“Rules for the survey and construction of steel ships” has been partly amended as follows:

Part C HULL CONSTRUCTION AND EQUIPMENT

Chapter 31B ADDITIONAL REQUIREMENTS FOR EXISTING BULK CARRIER

31B.5 Hold Frames

Fig.C31B.5.2 Sections a) and b)

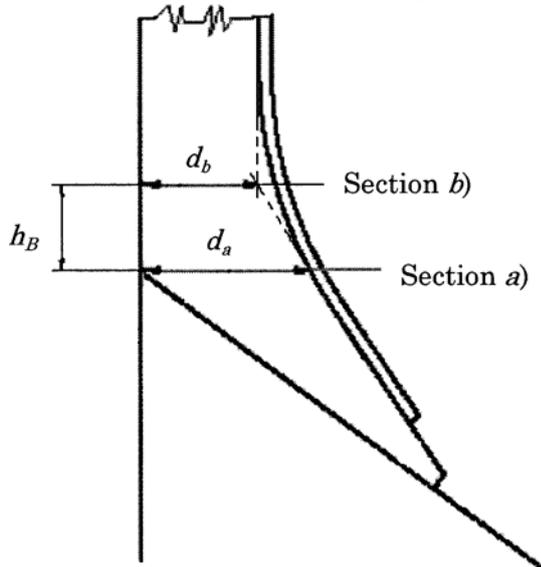
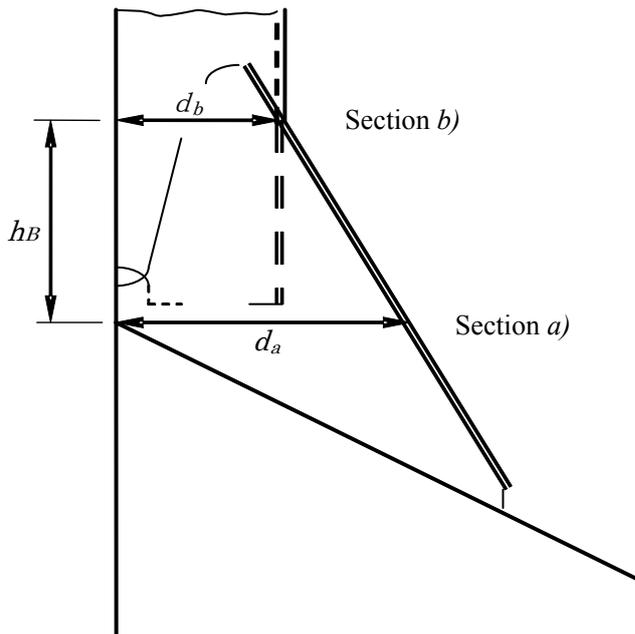
Fig.C31B.5.2 has been revised as follows.

d_a = lower bracket web depth
for determining $t_{REN,S}$

d_b = frame web depth

h_B = lower bracket length
